REFERENCE:	Nova Bus Manuals
SECTION:	14: Heating and ventilation
RS N°:	MQR 7621-869
EFFECTIVE IN PROD.:	—

SUBJECT:	A/C compressor belt
JUSTIFICATION:	A/C compressor belts may split down the center.

Figure 2 - A/C Compressor Support Rubber Mounts

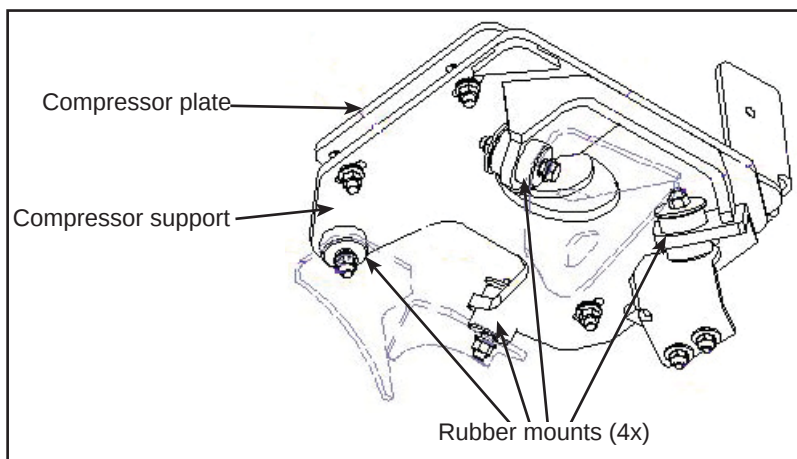
- 1.4. Remove the four rubber mounts on the A/C compressor support. See Figure 2. Discard the rubber mounts. Retain the remaining hardware.

- 1.5. Install the new N74196 (4x) rubber mounts on the A/C compressor support. Use the retained hardware.
- 1.6. Apply specified torque and torque sequence. See Figure 3.

Figure 4 - Compressor Plate Hardware Location

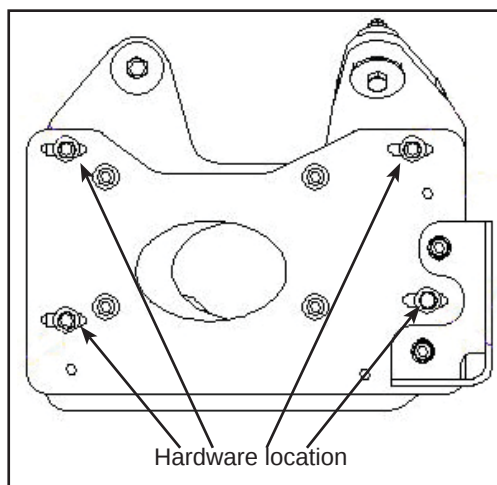
- 1.7. Remove the compressor plate M12 bolts (4x), nuts (4x) and washers. See Figure 4. Discard the hardware.

Figure 5 - New Hardware Location

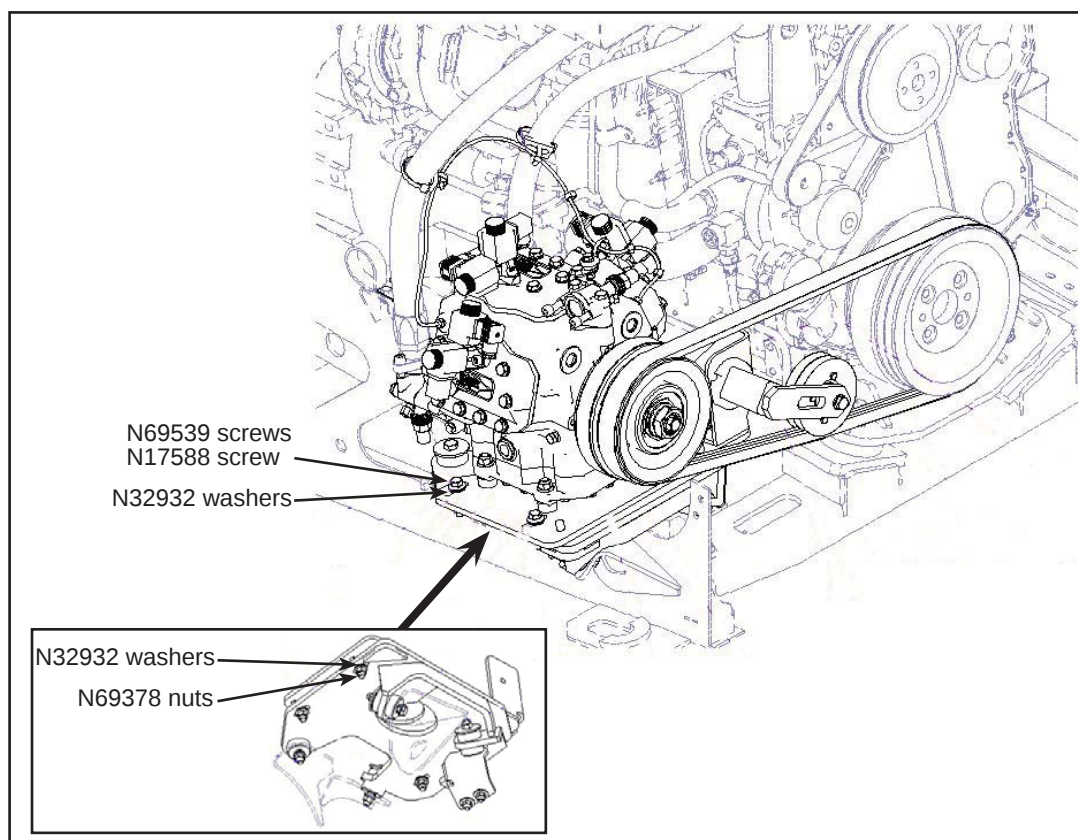
- 1.8. Install new hardware N69539 M12x50 class 10.9 screws (3x), N17588 M12x70 class 10.9 screw (1x), N69378 M12 class 10.9 nuts (4x) and N32932 M12 Nordlock washers (8x). See Figure 5. Hand tighten the hardware.

Disregard the compressor plate hardware torque value in the maintenance manual. Apply a torque value of 89 lb-ft (120 N•m) to the compressor plate screws.
